Project Name: Whataburger Albuquerque, NM SWC
Alameda Blvd & San Pedro Ave

Submittal Type: Administrative Amendment

Minor amendment site plan for an approved Whataburger restaurant located at 6100 Alameda NE Blvd. This request is necessary to update the building footprint/prototype from 2,999 SF (PT20S) to 2,816 SF (PT22S).

Administrative Minor Amendment to approved site plan for
a proposed fast-food restaurant,
located at the SEC of Alameda and San Pedro

PRELIMINARY SITE PLAN

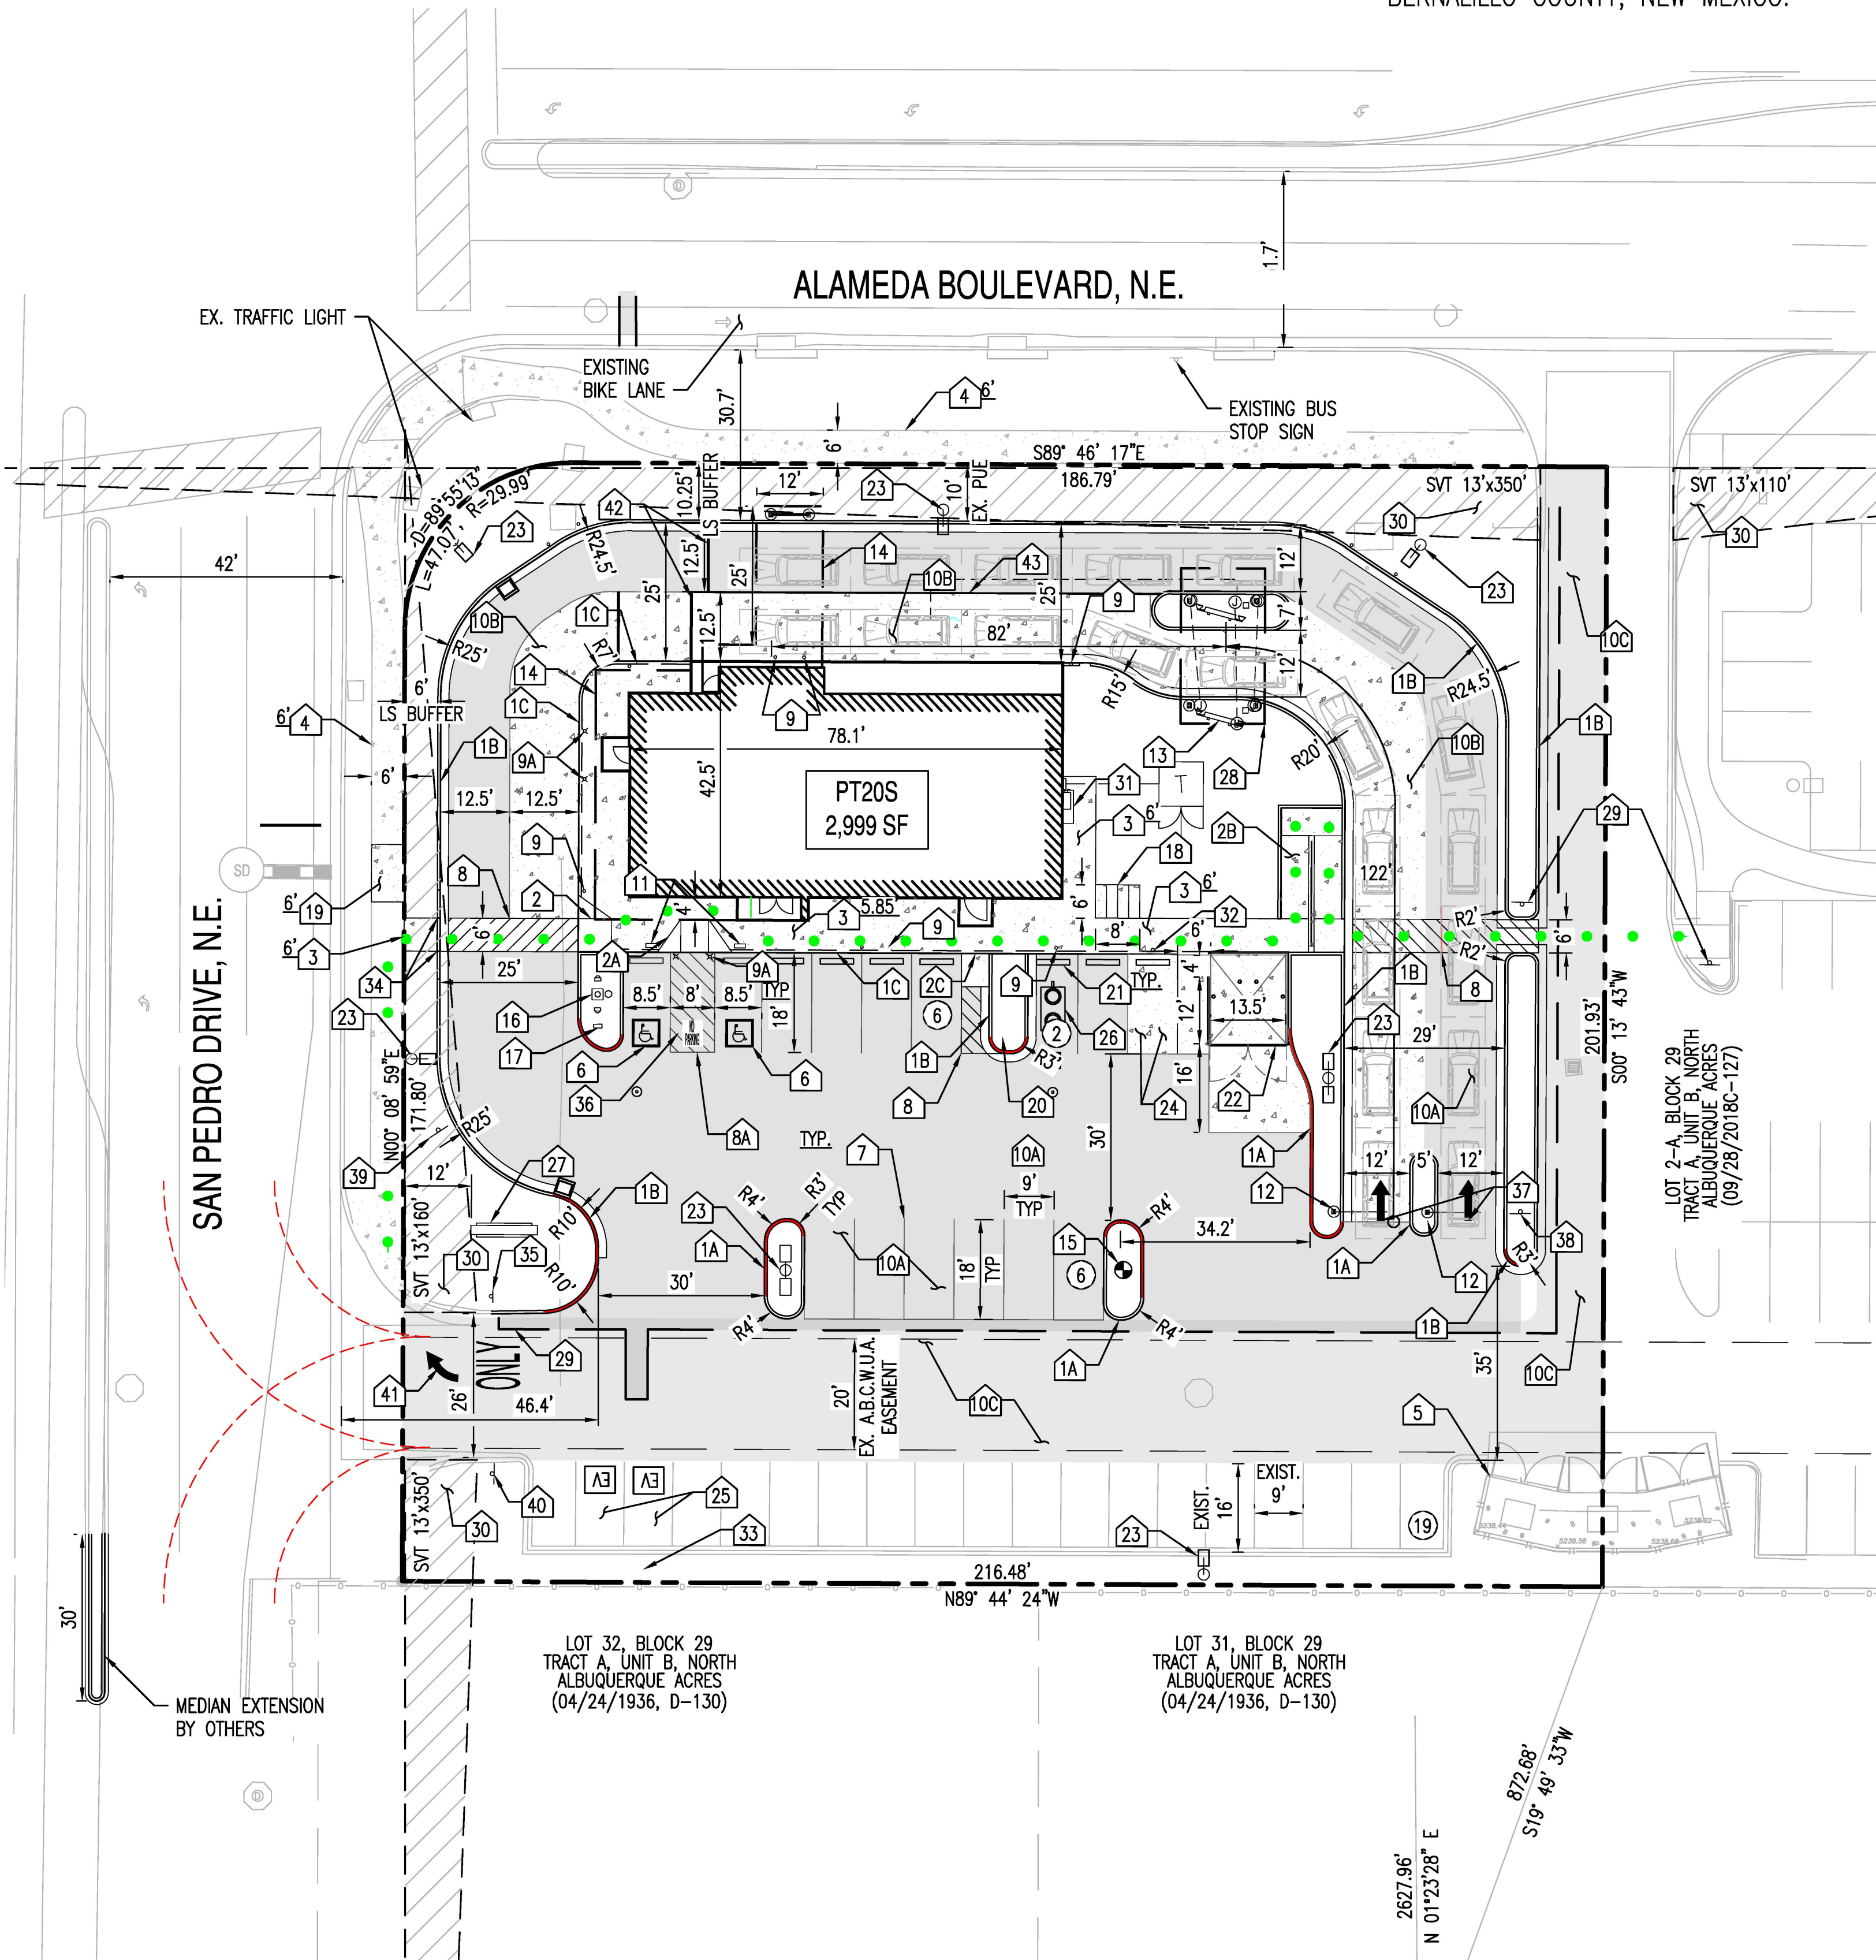
The overall site plan will remain unchanged from the approved version. The building and drive-through placement will remain on the north half of the lot while utilizing extra space on the south half for parking, access and vehicle circulation. The total square footage of the building was decreased to 2,816 SF with a parking count of thirty-three (33) spaces and two (2) motorcycle spaces, as required per IDO Parking Standards. Two (2) of the vehicle spaces will be electronic vehicle parking.

With the reduction of the building size and modification to building footprint, the drive-through was shifted south providing an additional 5 feet between Alameda Blvd and the drive-through pavement. However, the location of the sidewalk between the building and parking will remain unchanged.

- 1 SOUTH ELEVATION 2
- 1/4" = 1'-0"
- SIGN : 45 SF
- FACADE: 1,430 SF
- RATIO : 3%

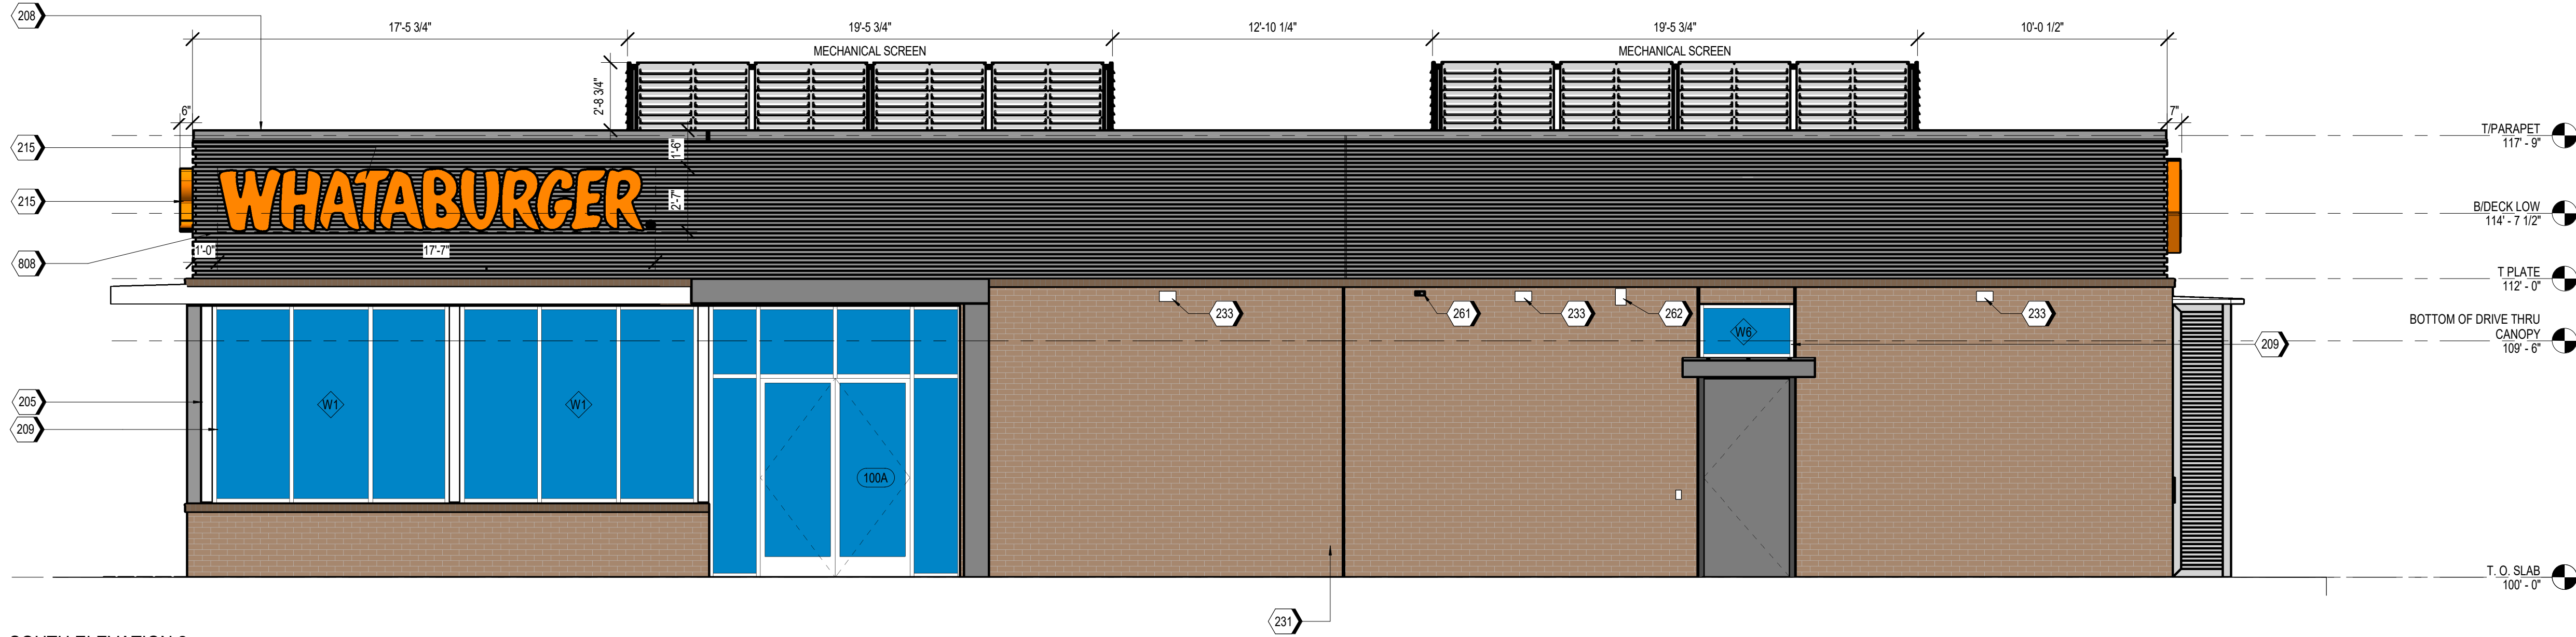
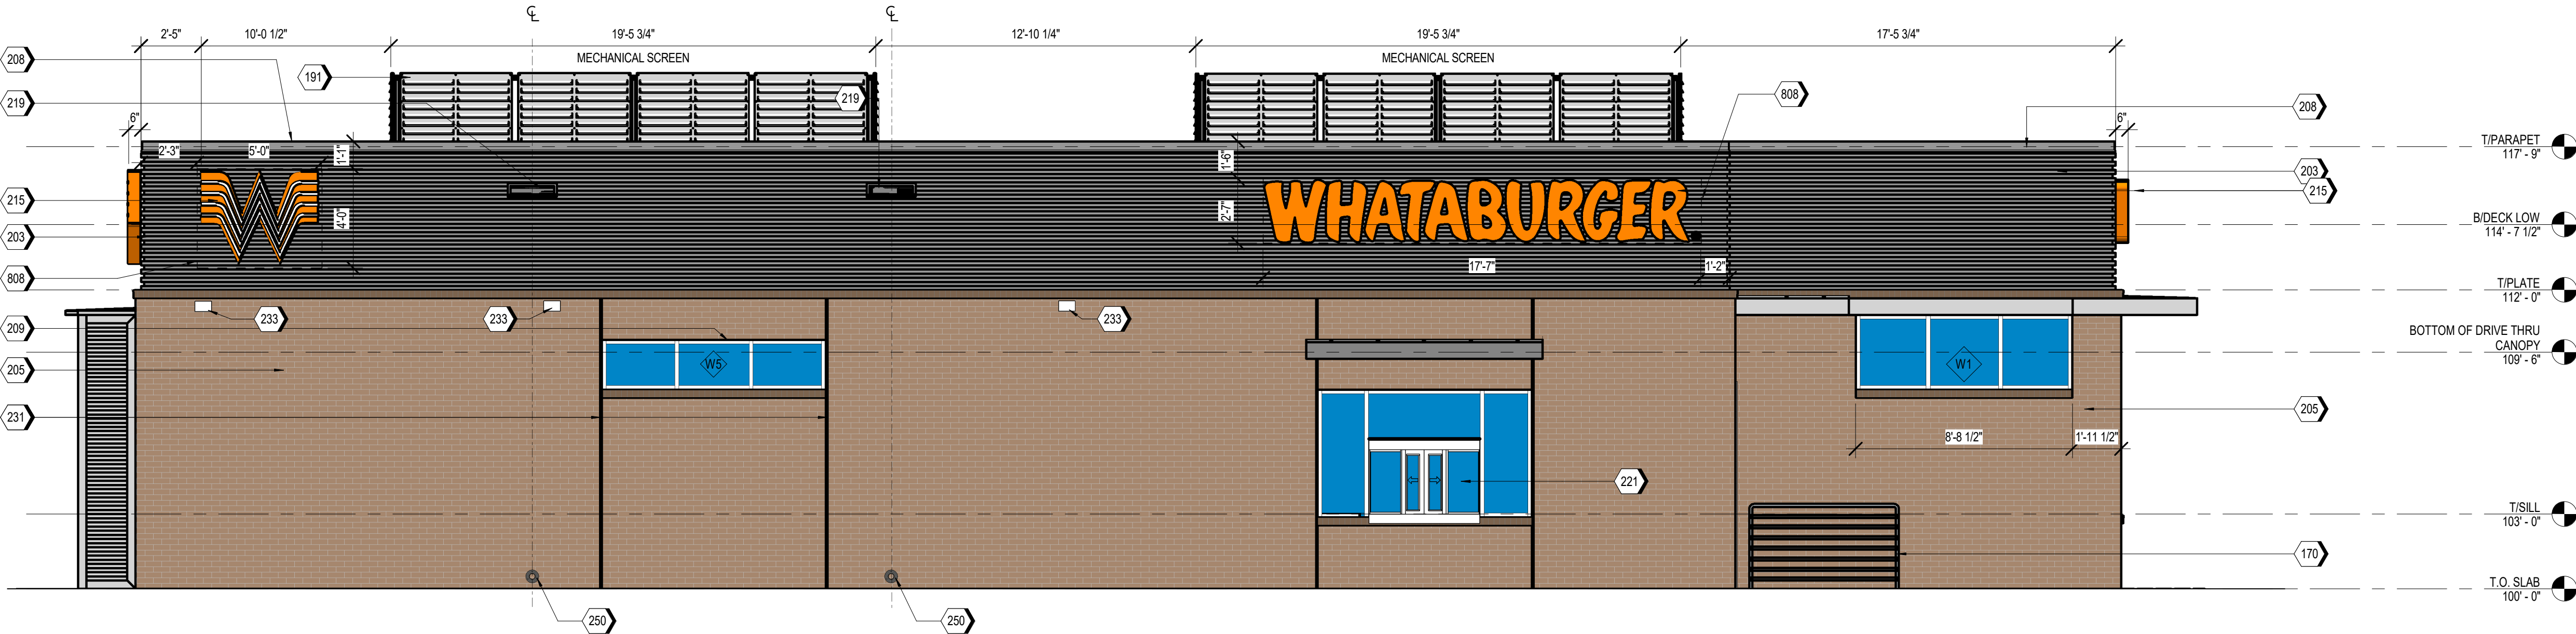
The building and architectural design of the building is proposed to remain generally consistent with the approved building elevations. Although the building prototype is updated, creating a change in the overall building footprint, this modification will be very consistent with the approved plans.

Each building facades contains diverse materials and colors that will create dimension and undulation for each building façade. The building also provides undulation along each building wall to help break apart any monotony in texture, plane, or material. In addition to the undulation and material changes throughout each facade, the building will also host varying color changes that will further diversity the plane of each façade
